**BOARD OF ZONING ADJUSTMENT
STAFF REPORT****Date: January 6, 2014****CASE NUMBER**

5874

PARKING RATIO: Parking Ratio Variance to allow 4 parking spaces for a 1,800 square foot office building in an I-1, Light Industry District.

ACCESS AND MANEUVERING: Access and Maneuvering Variances to allow an 8' access and 18' wide maneuvering .

SITE PLAN

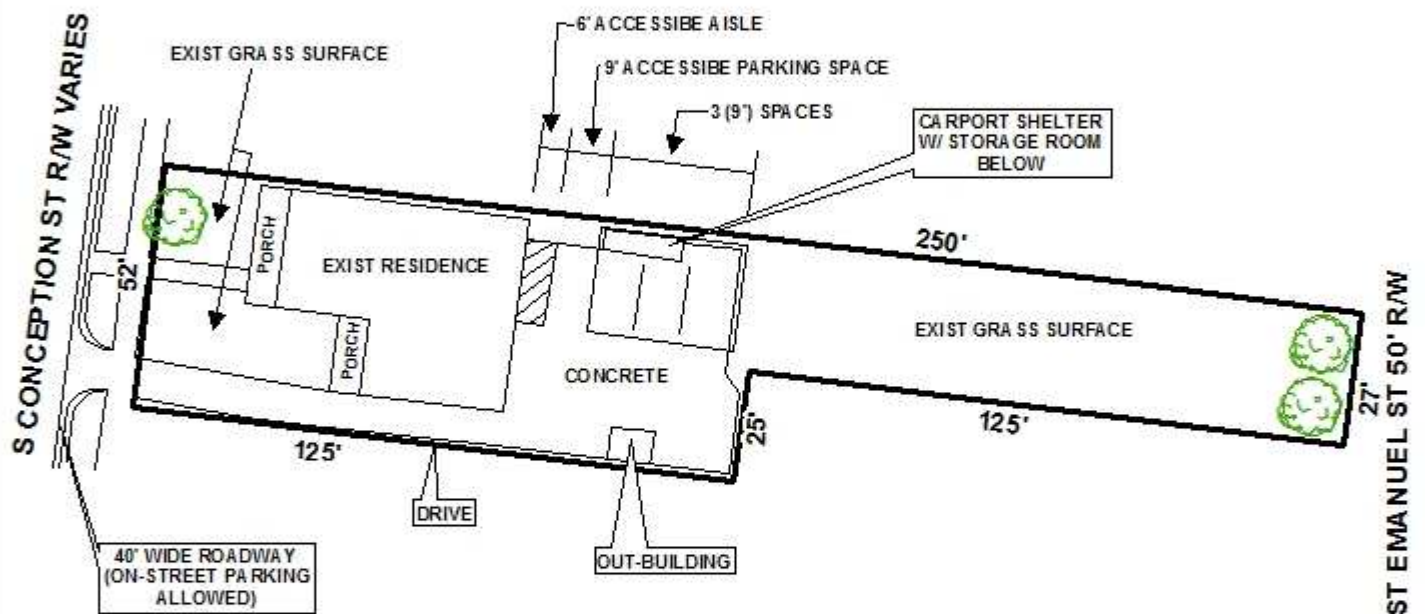
Site maneuverability would be greatly improved with the removal or relocation of the storage building on the south side of the property. Also, two of the three parking spaces proposed under the carport are partially obstructed by the columns for the structure. Either provide additional information indicating the parking space widths at the columns, or adjust the variance request for only three spaces onsite.

The applicant is proposing 4 on-site parking spaces in lieu of the 6 required spaces. Based on the site plan, it does not appear that the site will be able to adequately accommodate all 4 proposed parking spaces due to the existing free-standing carport shelter located to the rear of the property. It appears the existing free-standing carport shelter is 30' x 22' which would allow only 3 standard 9' x 18' parking spaces; however, there are three columns located on the corners of the carport which are not drawn to scale which makes it difficult to determine how much room will actually be available for the proposed 3 parking spaces. A revised site plan illustrating the width of the columns should be required to ensure the applicant is able to provide 4 on-site compliant parking spaces, or the applicant should revise his parking ratio variance request to 3 spaces.

In lieu of the required 24' access/ maneuvering drive and aisle the applicant is proposing an 8' wide driveway to the rear yard for one-way traffic and an 18' wide maneuvering area. It should be noted there appears to be an existing out-building for storage that is located directly behind one of the proposed parking spaces. Staff believes this will create maneuverability issues for the proposed site. Traffic Engineering has expressed concerns regarding the existing out-building as well and believes that the removal or relocation of the out-building will improve maneuverability.

It should be noted there is no dumpster illustrated on the site plan, nor is there a note stating that curbside pickup will be utilized. If approved, the site plan should be revised to either illustrate a dumpster in compliance with Section 64-4.D.9. of the Zoning Ordinance or place a note stating that curbside service will be utilized.

- 1) revision of the site plan to remove or relocate the existing out-building used for storage;
- 2) revision of the site plan to illustrating the width of the columns on the free-standing carport to ensure the applicant is able to provide 4 on-site compliant parking spaces;

- 3) alternatively, redesign the parking to provide 5 parking spaces facing East, showing removal of the existing carport and storage sheds;
- 4) revision of the site plan to indicate compliance with Section 64-4.D.9. of the Zoning Ordinance, regarding dumpsters.
